**UNITED STATES
NUCLEAR REGULATORY COMMISSION
ADVISORY COMMITTEE ON REACTOR SAFEGUARDS
WASHINGTON, DC 20555 - 0001**

SUBJECT: CERTIFICATION OF THE MINUTES OF THE ACRS
 NUSCALE SUBCOMMITTEE MEETING DECEMBER 18,
 2018, IN ROCKVILLE, MARYLAND

ADVISORY COMMITTEE ON REACTOR SAFEGUARDS
NUSCALE SUBCOMMITTEE MEETING

December 18, 2018

Figure 17.4-1: NuScale D-RAP Process for SSC Risk Significance Determination

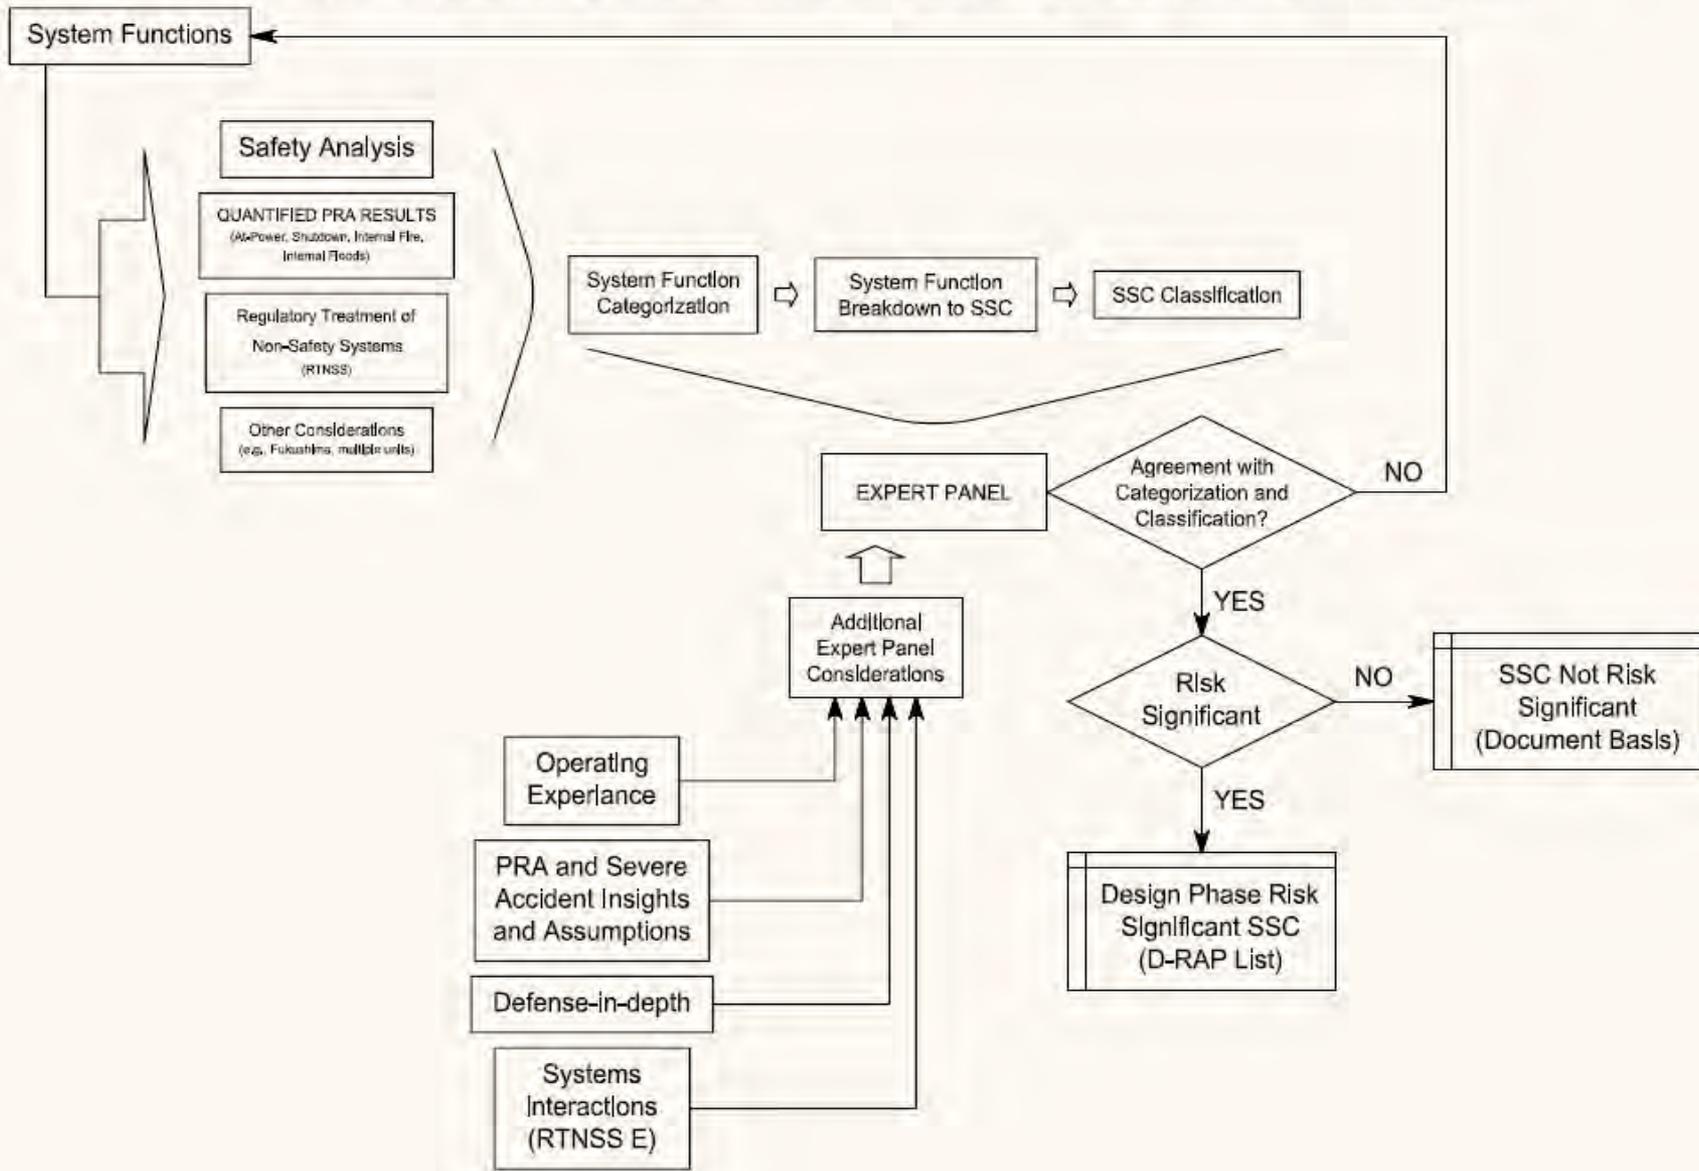
15 What you see here is a figure from the DCA
16 submittal in Chapter 17.4, and this basically outlines
17 the D-RAP process. What I wanted to point out on this
18 slide are a few things here, and it kind of goes back
19 to your question about the program and process itself.
20 We have the safety analysis. We have the results. We
21 look at RTNSS during this process. We also look at
22 other considerations, like Fukushima, other operating
23 experience, what we've learned through our own
24 experiences working with the design. And those will
25 be inputs for the classification that the system

1 the SRP. The staff confirmed that the expert panel
2 considered the appropriate inputs, in addition to the
3 probabilistic information, for the selection of risk-
4 significant SSCs. And the staff reviewed the final
5 list of D-RAP SSCs which are those required to perform
6 risk-significant system functions and verified the
7 process described in FSAR Figure 17.4-1.
